**Re: Spring Creek North Continuation Project Information Request Response**

This letter has been prepared to address the Departments request for information (RFI) to assess the application to amend environmental authority EPML00370013 (application reference A-EA-AMD-100430427), issued to Rolleston Coal Holdings Pty Ltd (RCH) on 19th July 2023.

**Table 1** of this letter contains the RFI as provided by the Department, and the relevant response from RCH, incorporating information and advice from technical specialists. Section 2 contains additional supporting information, referenced within the **Table 1** responses.

**Figure 1** Prescribed regional ecosystems within a defined distance from the defining banks of a relevant watercourse.

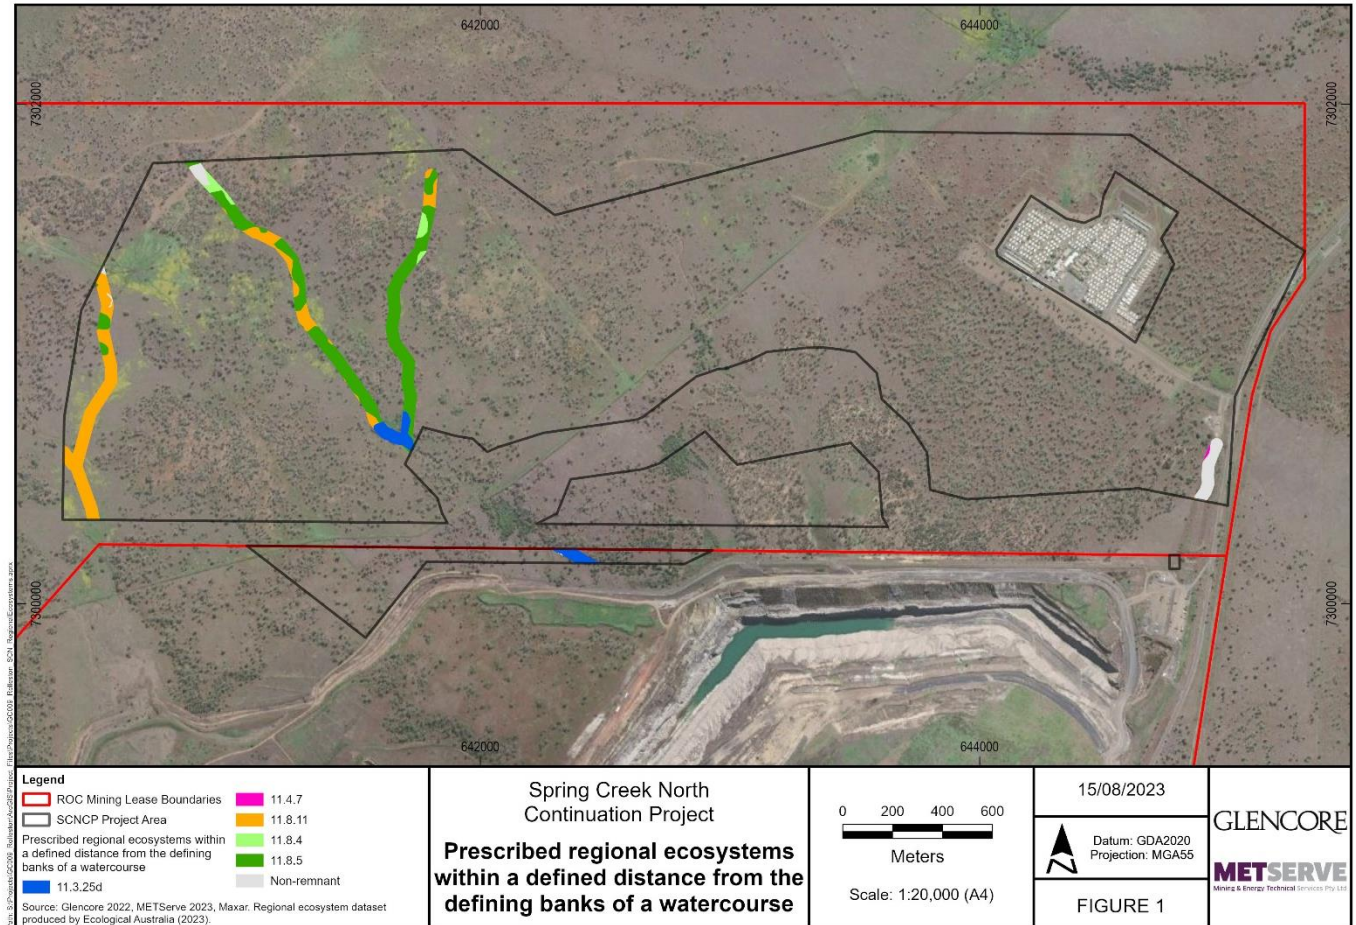
<p><b>7</b></p>	<p><b>Offsets</b></p> <p>Table 22 'Summary of SIA for MNES and MSES occurring within the Project area (E2M, 2023)' in the supporting information document identifies that</p>	<p>Provide a breakdown of the 20.5ha of "prescribed REs within a defined distance from the defining banks of a relevant watercourse".</p>	<p>A detailed breakdown of the 20.5 ha of "prescribed REs within a defined distance from the defining banks of a relevant watercourse" to show specific regional ecosystems has been provided by Ecological Australia and</p>

Item	Issue	Request	Response																
	<p>there will be a significant residual impact to 20.5ha of ‘Prescribed REs within a defined distance from the defining banks of a relevant watercourse’. However, a breakdown of the specific regional ecosystems (REs) is not provided. This information will be necessary to amend Table K1 in the EA, if the application is approved.</p>		<p>is provided below. Section 2.1 provides a Figure depicting the location of each RE, along each relevant watercourse.</p> <p>An update to EA Table K1 to incorporate these values is included in Section 2.2.</p>

**Figure 1** provides the location of prescribed regional ecosystems within a defined distance from the defining banks of the relevant watercourses.

**Figure 2 ROC All Sites EC Sodium Correlation**

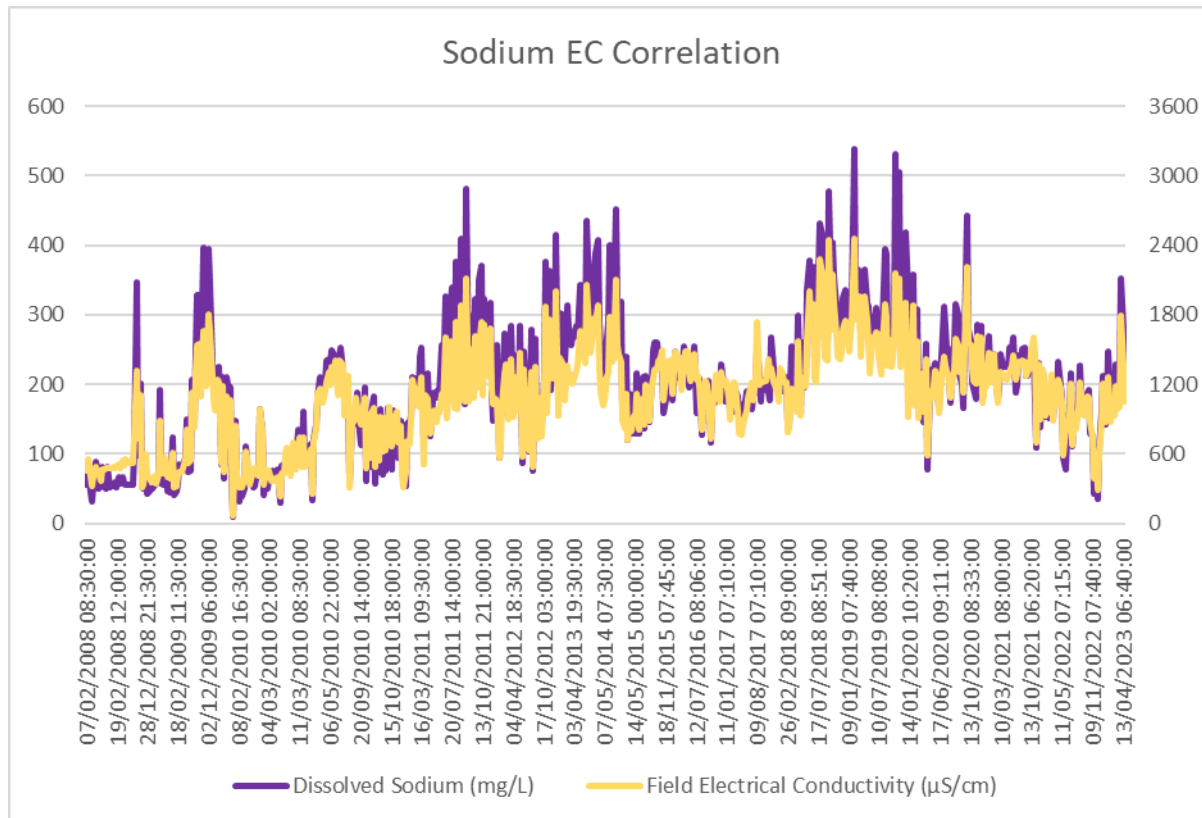
- a) *Provide a detailed summary of, and all raw historic data, relating to mine water releases for sodium and EC, including a correlation analysis.*
- b) *Pending the outcome of item a) above, clarify if the sodium trigger value sought from the amendment is appropriate when compared to the maximum release EC of 1,800 µS/cm.*

The ratio of EC to Na within ROC release waters averages 5.8 x EC to Na, with a max of up to 10.6 x EC to Na, and a minimum of 2.7 x EC to Na. These are minimum and maximum values and so include several anomalous results which could be attributed to sampling or administrative errors, however the 10<sup>th</sup> and 90<sup>th</sup> percentiles of 4.7 x and 7.6 x respectively, indicate that there is a clear correlation between EC recorded and sodium limits within ROC release waters.

A sodium level of 300,000 µg/L represents the 86<sup>th</sup> percentile of the 580 samples used for this correlation analysis (down from 87<sup>th</sup> percentile for all 676 sample events). As per **Table 3**, the 86<sup>th</sup> percentile for EC samples across site is 1541 µS/cm.

While this 1541 µS/cm value is lower than the 1,800 µS/cm release limit for EC within the ROC EA Table D4 (**Table 4**), it is important to note that the 1,800 µS/cm limit on EC is only applicable to high flow release events, where receiving waters are flowing at up to 5m<sup>3</sup>/s for Bootes Creek, and more than 15m<sup>3</sup>/s for Meteor Creek. An EC release limit of 1,600 µS/cm is in place for medium flow release events, where receiving waters are flowing from between 1m<sup>3</sup>/s and 2.5m<sup>3</sup>/s for Bootes Creek, and 2.5m<sup>3</sup>/s and 7.5m<sup>3</sup>/s for Meteor Creek. As the proposed 300,000 µg/L release limit for sodium within EA Table D3 will apply across all releases, even low flow releases where EC release limits can be as low as 280 µS/cm for Bootes Creek (under 1m<sup>3</sup>/s flow rate) and 324 µS/cm for Meteor Creek (under 2.5m<sup>3</sup>/s flow rate), using trigger levels for EC rather than sodium within EA Table D3 could be considered considerably more conservative.

**FIGURE 5.7**

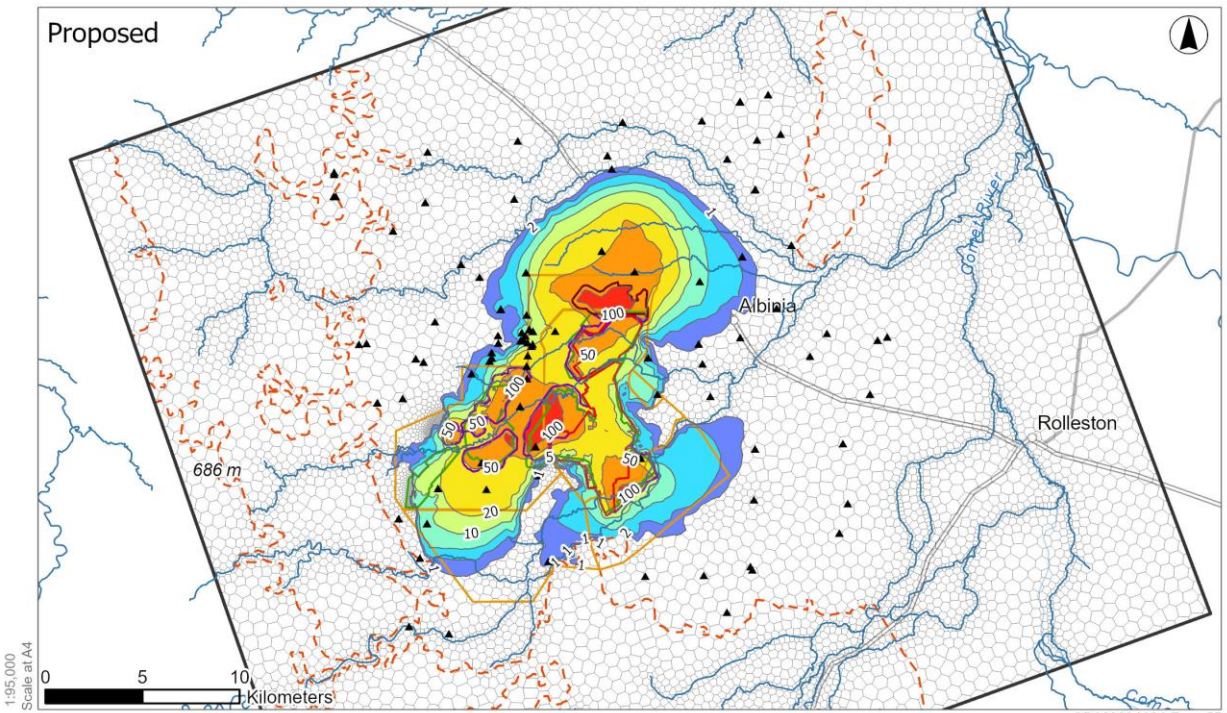
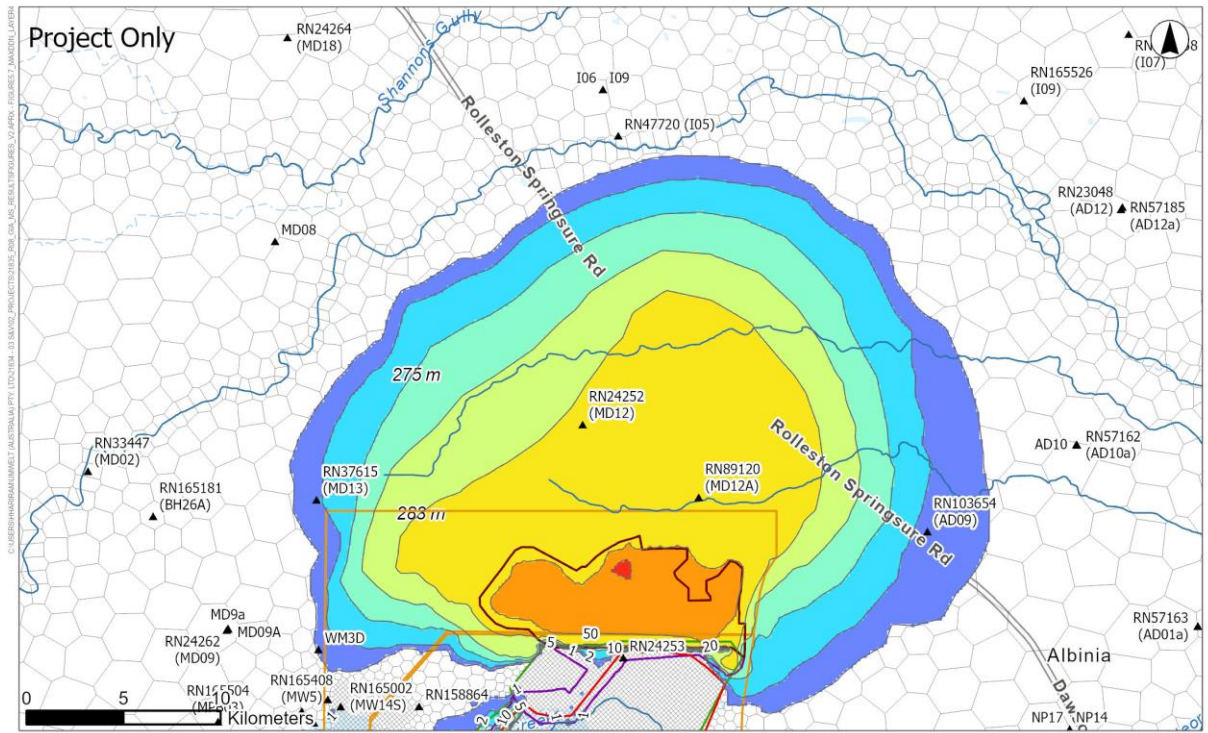
Item	Issue	Request	Response
	<p>spoil areas (PZ holes) but these holes don't appear to have been used in the calibration.</p>		<p>600 kPa and 900 kPa respectively. This increase in pressure reflects permeability changes with compaction and settlement of spoil over time. The influence on predictions of changes in spoil properties was captured in the model scenario analysis, with changes in the spoil hydraulic conductivity between 1.0 m/day and 0.01 m/day.</p> <p>b) Mining at MDS was included in the model, with the mining commenced from 2018 and targeting the D Seam of the Blackwater Group. The modelled mine progression and timing for MDS is presented in Umwelt (2023) Appendix B Figure 2.10 Historical Mine Progression (Calibration Period). As shown in the figure mining commenced from stress period 66, represented in the model as the first quarter of 2018.</p> <p>The modelled mine progression for the predictive scenarios are also presented in Appendix B of Umwelt (2023) Figure 2.11 Proposed Mine Progression and Dewatering for the Entire Length of Simulation.</p> <p>Refer to Section 2.4 for a copy of the map.</p> <p>c) MDS bores were included in the conceptualisation and modelling, with the bores presented in the model calibration results in Appendix B of Umwelt (2023), under Appendix 1 Calibration Residuals. The bores are shown in the table as:</p> <ul style="list-style-type: none"> <li>• 165502 PB01 – represented as MPB01: absolute average residual of 0.0188 layer 4.</li> <li>• 165503 PB02 – represented as MPB02: absolute average residual of 4.2043 layer 4.</li> </ul>

Item	Issue	Request	Response
			<ul style="list-style-type: none"> <li>• 165504, PB03 – represented as MPB03: absolute average residual of 9.978 layer 4.</li> </ul> <p>The bores are located on Glencore owned land so were not included in the initial bore summary report table, but have been included in Table 6 of this document.</p> <p>The three bores are located outside of the extent of predicted drawdown due to the SCNCP. The bores are located approximately 1.7 km to 2.5 km from the edge of the 1 m drawdown extent for the Project as shown Umwelt (2023) Figure 5.7 Predicted Maximum Drawdown: Project Only (top) and Proposed (lower) – Layer 4. Refer to Section 2.5 for a copy of the maps with the bores labelled.</p> <p>d) Details on the geotechnical spoil holes were provided following completion of the model calibration. This data was provided prior to recovery modelling and was used to verify the ability of the model to replicate current groundwater conditions in the spoil. Further details on this are provided in Section 2.6.</p>

The predicted drawdown figure (Figure 5.7) relevant to the bores is also included below with the bore locations annotated. The bores are located outside the extent of predicted drawdown for the SCNCP, therefore no additional drawdown is predicted due to the Project. The bores are also outside the 2m extent predicted drawdown for the Project plus the Rolleston Open Cut Life of Mine (ROC LOM) plan, which is referred to in the figure as "Proposed".
